10/711,326

Office Action Summary	Application No. 10/711,326	Applicant(s) NAKANO ET AL.	
	Examiner THOMAS W. IRVIN	Art Unit 3657

DETAILED ACTION

Figs. 1 and 2 (US Patent 3,168,836)

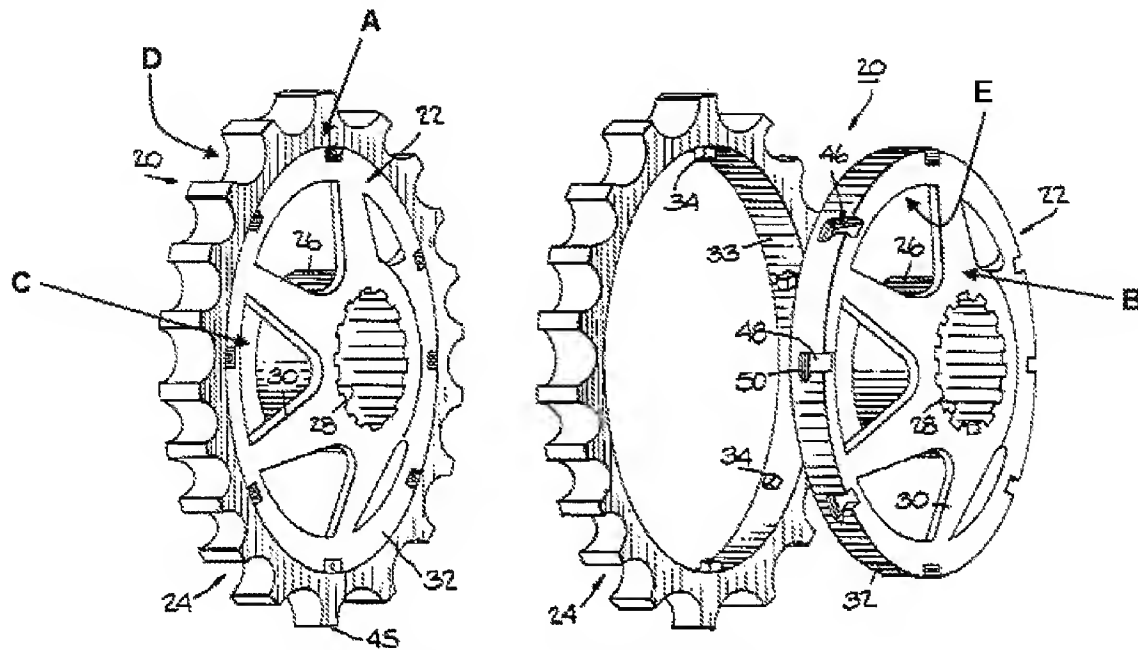
In Re claim 1, with reference to Figs. 1 and 2 shown above, Militana discloses a sprocket, wherein the sprocket comprises: a sprocket body (20); a plurality of teeth (45) extending radially outwardly from the sprocket body; a spline (28) extending radially inwardly from the sprocket body; wherein the spline includes a radially outer surface (26) facing radially outwardly; and wherein the radially outer surface of the spline faces a radially inner surface (E) of the sprocket body.

In Re claim 5, the sprocket body has a side wall that includes a first side wall portion (A) and a second side wall portion (B), wherein the plurality of teeth extend radially outwardly from the first side wall portion, and wherein the second side wall portion is laterally offset from the first side wall portion.

In Re claim 6, the second side wall portion overlaps the outer surface (26) when viewed in a direction parallel to the rotational axis.

In Re claim 9, the spline extends from the second side wall portion and terminates at a free end (C), and the free end is spaced apart from a first side wall (D) of the first side wall portion (A) that faces in a same direction as the free end.

In Re claim 10, the sprocket body has a side wall that includes a first side wall portion (A) and a second side wall portion (B), wherein the plurality of teeth extend radially outwardly from the first side wall portion. It is the examiner's understanding that the second side wall portion and the spline together form a composite spline.

In Re claim 13, with reference to Figs. 1 and 2 shown above, Militana discloses a bicycle sprocket, wherein the sprocket comprises: a sprocket body (20); a plurality of

teeth (45) extending radially outwardly from the sprocket body; a spline (28) extending radially inwardly from the sprocket body, wherein the spline has a root portion (30) and a radially inner portion (26), wherein the root portion extends radially inwardly of the sprocket body and has a side wall (B) facing in a rotational direction, and wherein the radially inner portion extends radially inwardly of the root portion and has a side wall (C) facing in the rotational direction; and wherein a thickness of the radially inner portion of the spline in a direction parallel to the rotational axis is greater than a thickness of the root portion of the spline in a direction of the rotational axis.
